**LEBANON PLANNING BOARD
APRIL 14, 2025 - 6:30 PM
COUNCIL CHAMBERS, CITY HALL OR
REMOTE VIA VIRTUAL PLATFORM
LEBANONNH.GOV/LIVE**

Staff Memorandum – PB2024-48-SPRCUP – *con't from 3/17/25*

Cicotte Holdings, LLC, 51 Evans Drive (Tax Map 78, Lot 40, Plot 200), zoned R-O-1: Request for a Conditional Use Permit pursuant to Section 311A.2 of the Lebanon Zoning Ordinance** and for Site Plan Review per Section 3.1.D of the Site Plan Review Regulations to expand the outdoor vehicular storage area for an existing vehicular sales use together with associated site improvements including landscaping and lighting. PB2024-48-SPRCUP

DETAILED GRADING PLAN

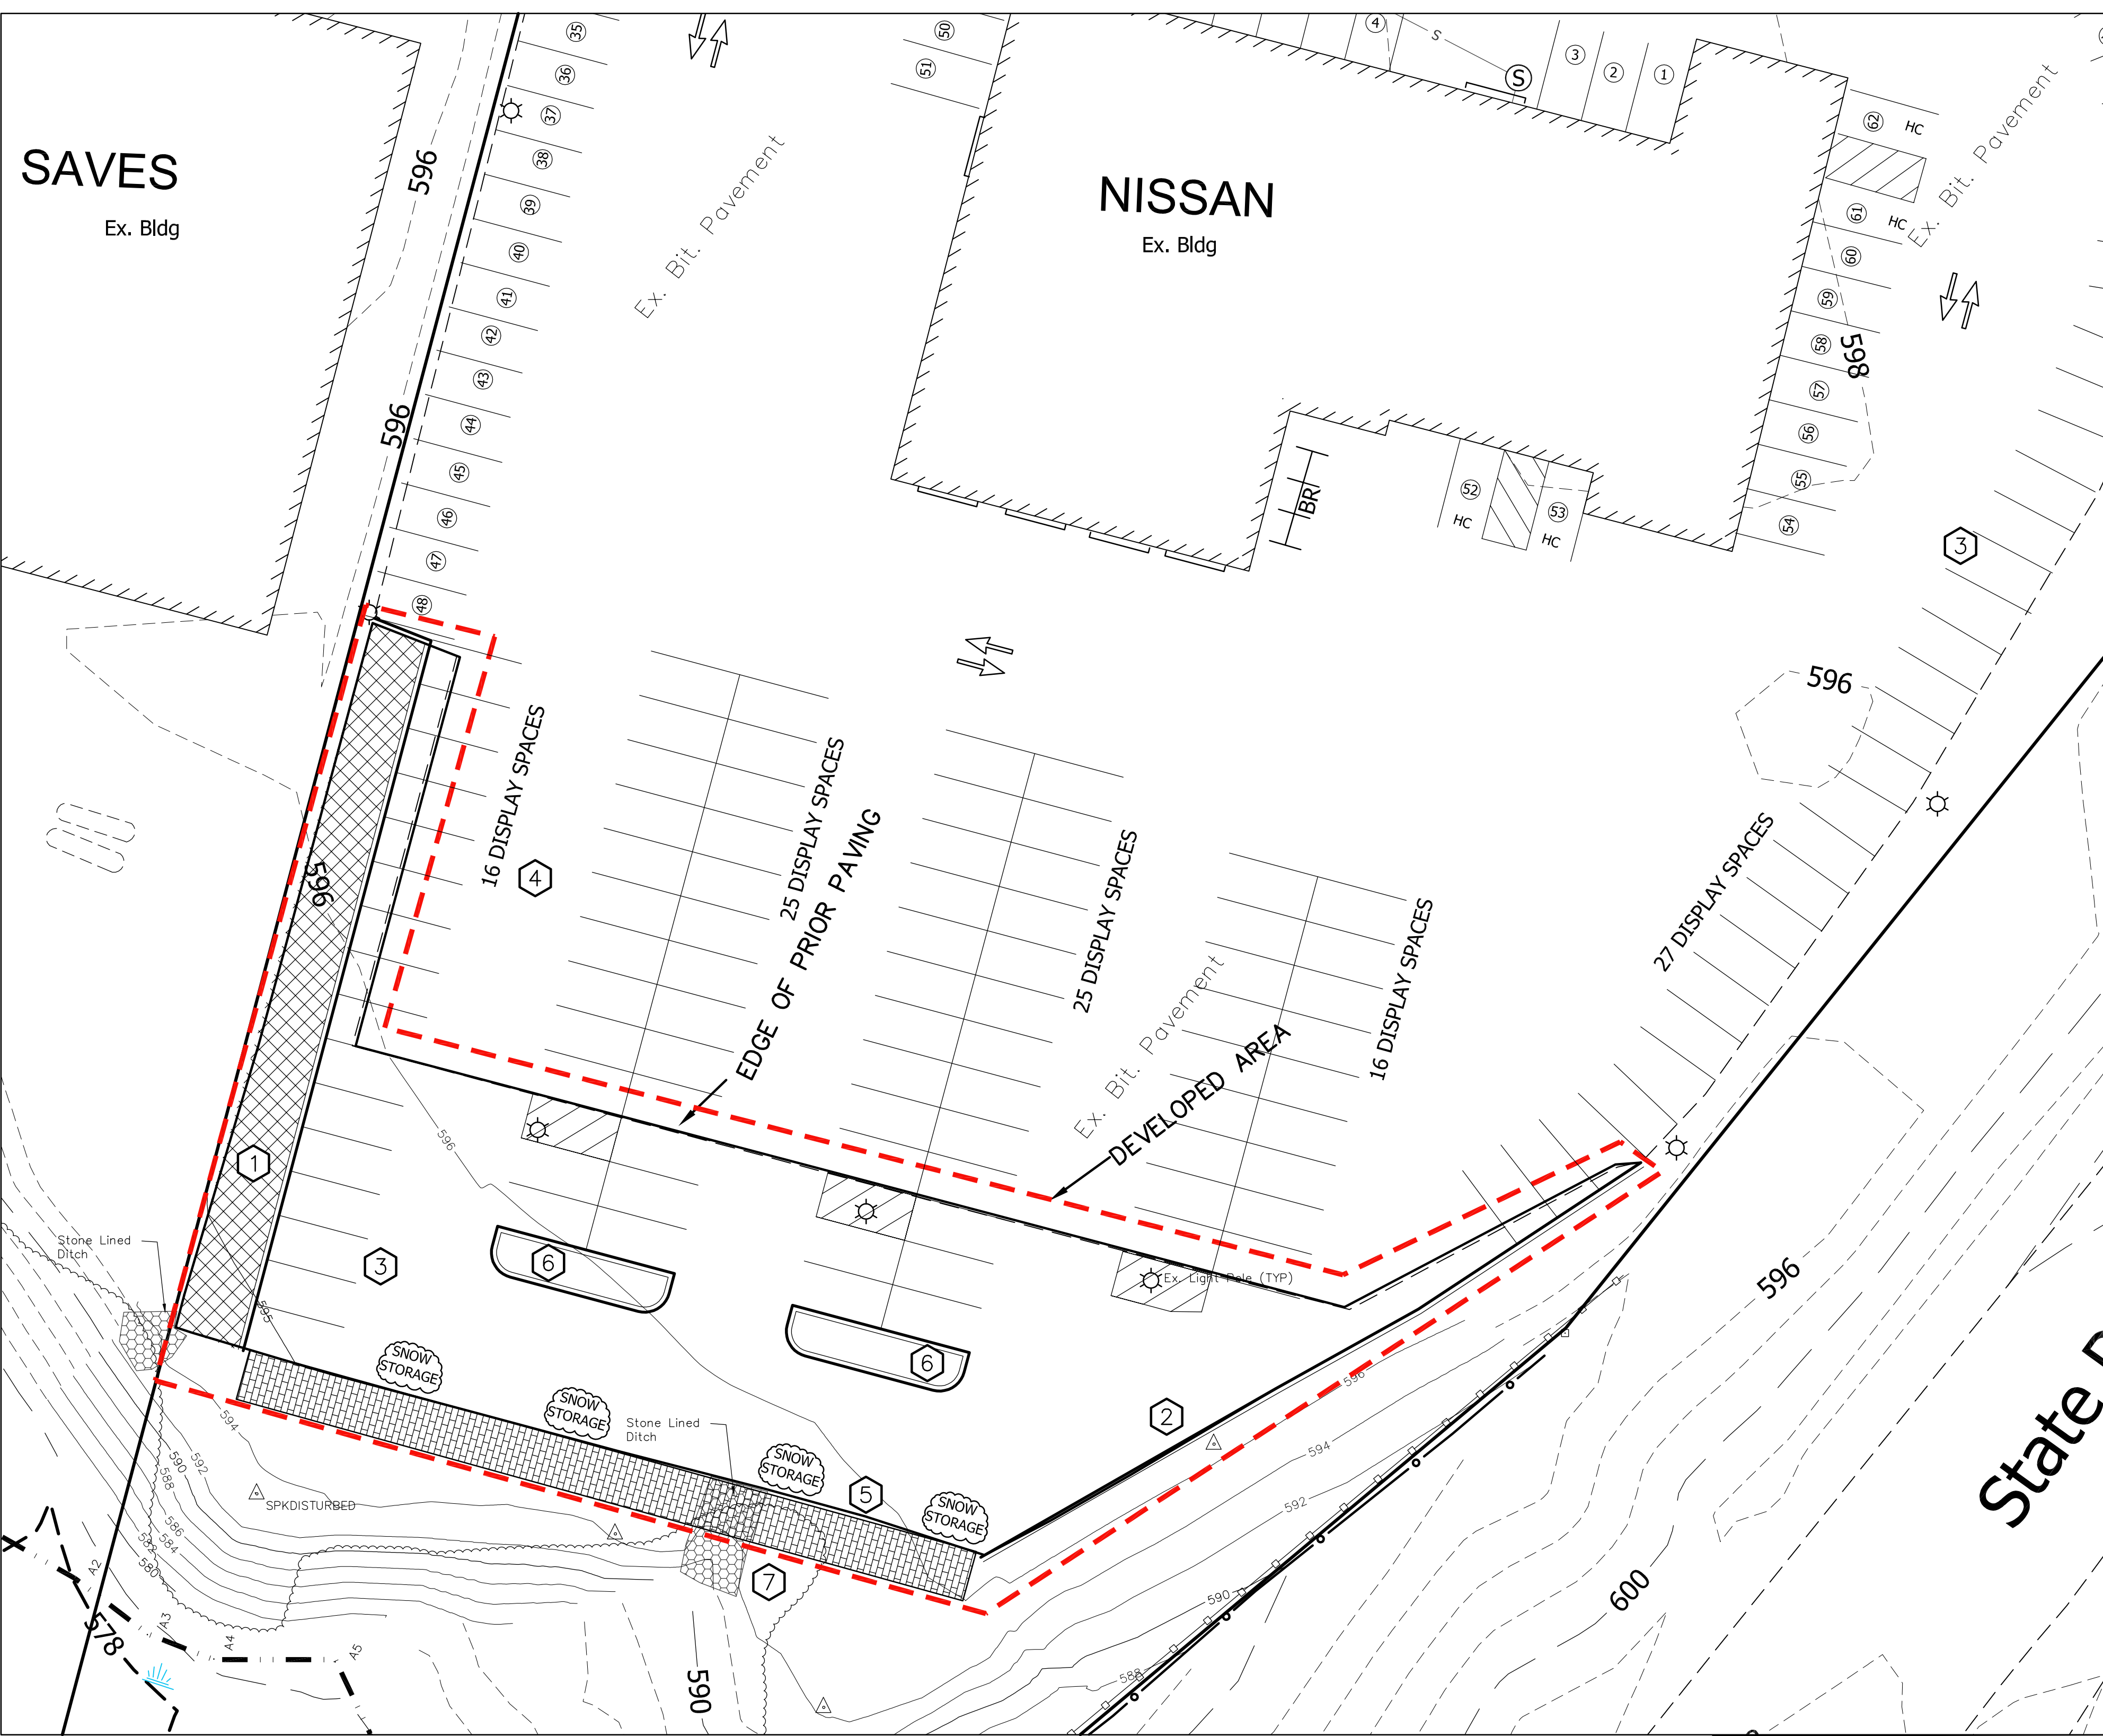
- As depicted on the attached "Detailed Grading Plan for Lebanon Nissan," with a revision date of March 19, 2025, the applicant has again reconfigured the site layout. See Figure 3 below. In adding parking spaces and aisles, the latest proposed layout obviates the potential need for waivers from Section 6.5.E.3 ("Parking spaces shall measure a minimum of 9 x 18 feet") and Section 6.5.E.4 ("Aisles between parallel rows of spaces shall be a minimum of 24 feet wide.") as had been suggested in the staff memo prepared for the March 17th Planning Board meeting. Note that all other requested waivers (as set forth in the attached Application for Waivers) are still needed.

- The revised layout also adds 7-ft. wide “raised islands” with “sloped granite” at the southern end of two of the three proposed double-parking rows. The plan sheet does not identify what is proposed to be placed or planted within the raised islands.
- Ideally, the applicant would have provided an updated plan set that reflects the proposed site layout (i.e. the site plan and landscaping sheets included within the plan set submitted for the March 17th plan set depict the prior layout without striping, aisles, and landscaping aisles). At a minimum, updating the plan set to reflect the proposed layout (if approved by the Planning Board) will need to be made a condition of site plan approval.
